BWR OWNERS' GROUP

BWROG-00073
July 20, 2000

SUBJECT: ***BWR Owners' Group Appendix R Fire Protection Committee
Use of Safety Relief Valves and Low Pressure Systems as Redundant Safe
Shutdown Paths, GE Report No. GE-NE-T43-00002-00-03-R01, August 1999***

BWROG Comments
On the NRC (PSA Branch)
Risk Assessment of the
BWROG Position on the Use of
Safety Relief Valves and Low Pressure Systems
As Redundant Safe Shutdown Paths

Figure 1 - SRV/LPS Protected as Required Safe Shutdown Path

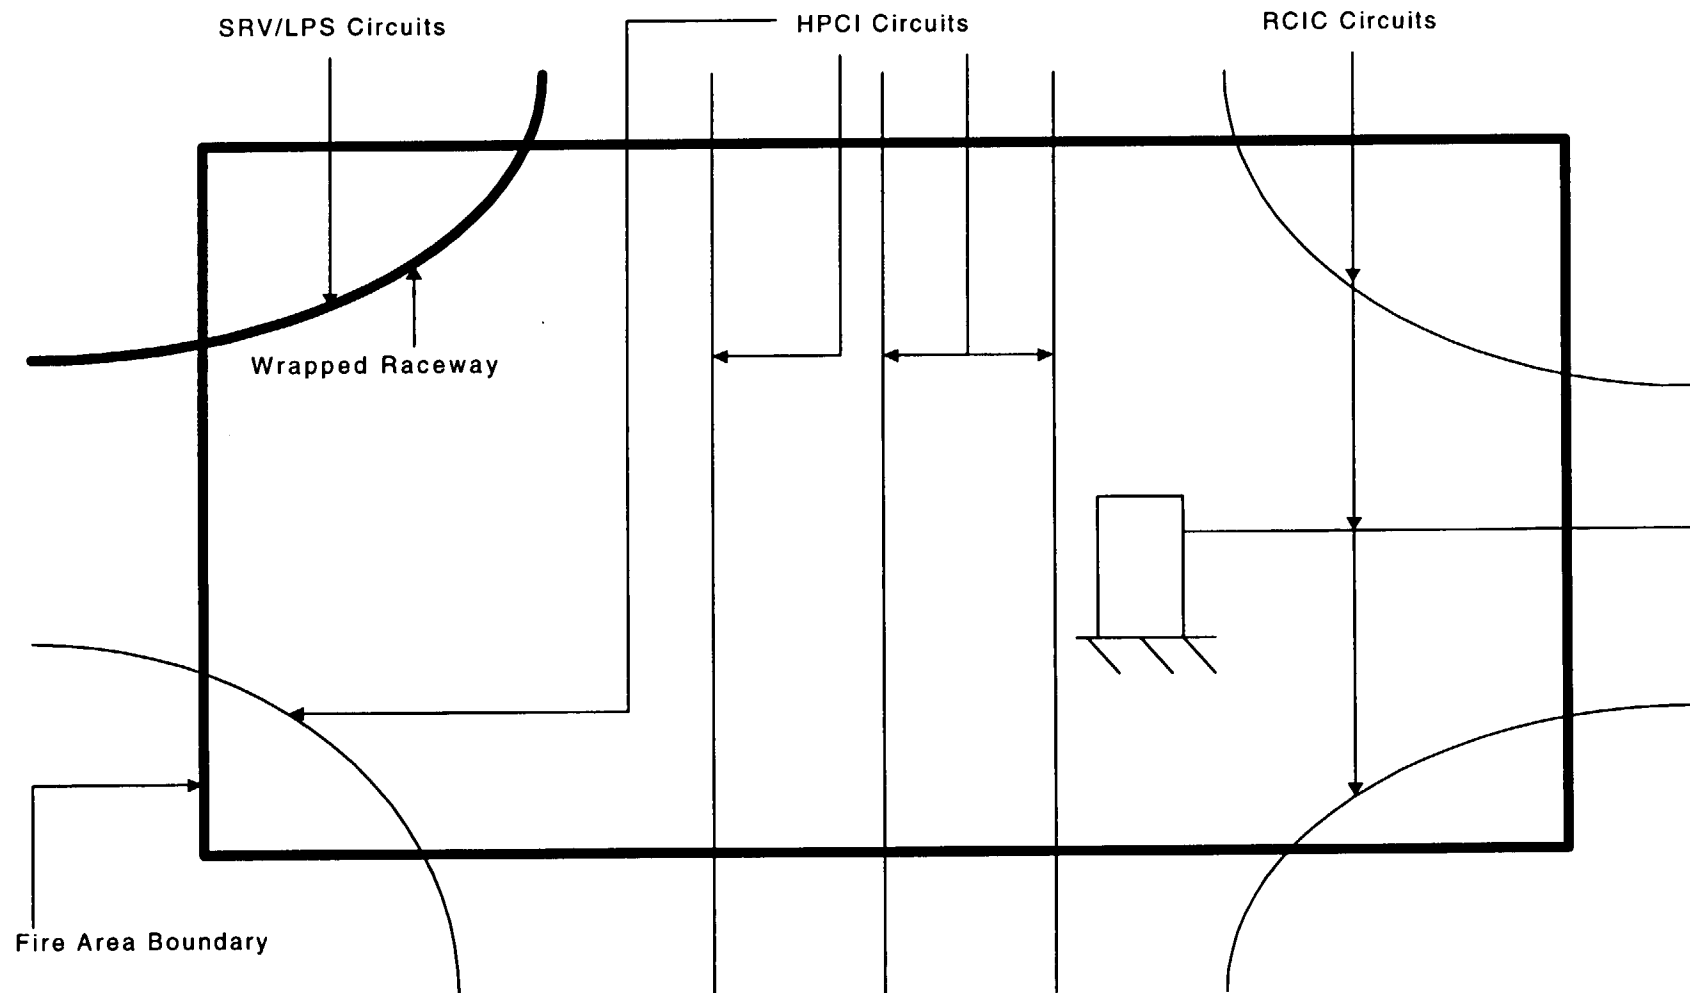
Regarding assumption No. 1 above, BWRs have extensively used SRVs/LPS as Redundant Safe Shutdown Paths in situations where the SRV/LPS path is **not** independent of the fire area under evaluation. As shown in the attached Figure 1, circuits for the SRV/LPS safe shutdown path are routed in the same fire areas as circuits for

HPCI/HPCS, RCIC and other means of achieving and maintaining safe shutdown. It is the BWROG's Position that safe shutdown paths using SRVs/LPS are acceptable Redundant Safe Shutdown Paths. The BWROG considers safe shutdown paths using SRVs/LPS to be redundant and equivalent to safe shutdown paths using HPCI/HPCS, RCIC or any other means of achieving and maintaining safe shutdown. As shown in the attached Figures 1 and 2, BWRs have protected the redundant safe shutdown path that is least affected by the fire. If SRV/LPS was the least affected path, it would be selected as the required safe shutdown path (Refer to Figure 1). Conversely, if HPCI were the least affected path, it would be selected as the required safe shutdown path (Refer to Figure 2). The BWROG also believes that the licensing basis citations provided in Attachment 2 to this letter substantiate the fact that the use of SRVs/LPS has been approved by the NRC staff as a Redundant Safe Shutdown path. Therefore, the assumption that SRVs/LPS are used as Alternative Shutdown Paths and are independent of the fire area under evaluation is not applicable to the BWROGs position on the use of SRVs/LPS as Redundant Safe Shutdown Paths.

Figure 1 - SRV/LPS Protected as Required Safe Shutdown Path

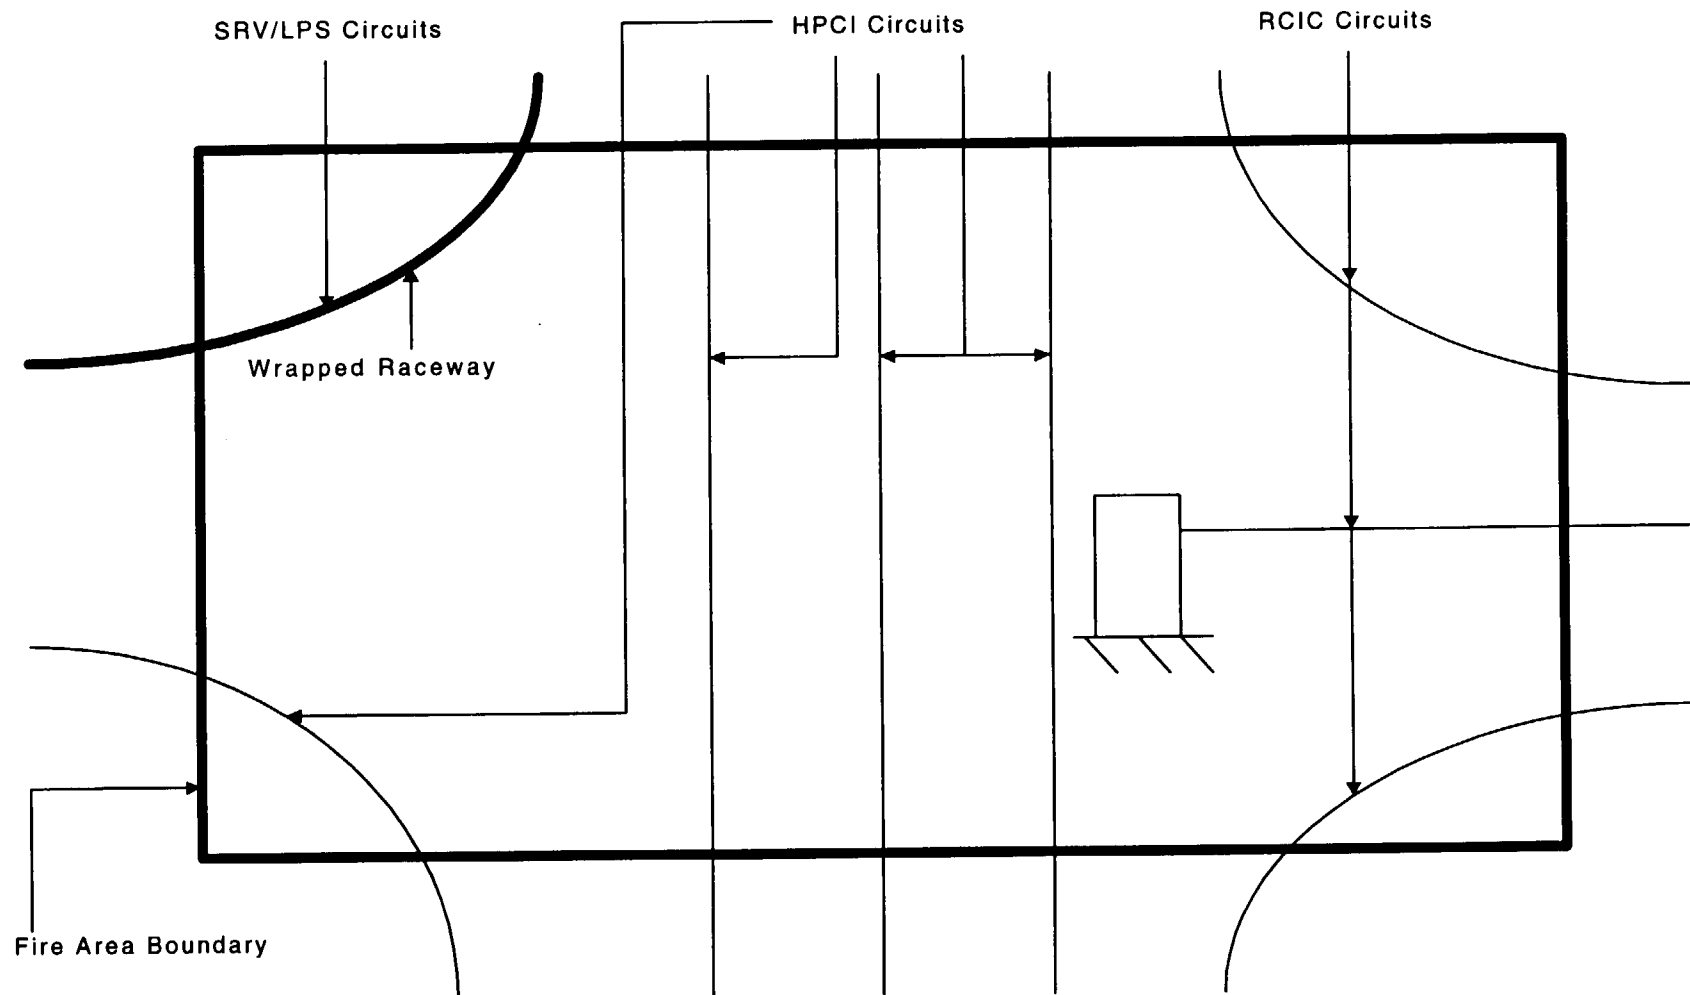
Regarding assumption No. 1 above, BWRs have extensively used SRVs/LPS as Redundant Safe Shutdown Paths in situations where the SRV/LPS path is **not** independent of the fire area under evaluation. As shown in the attached Figure 1, circuits for the SRV/LPS safe shutdown path are routed in the same fire areas as circuits for
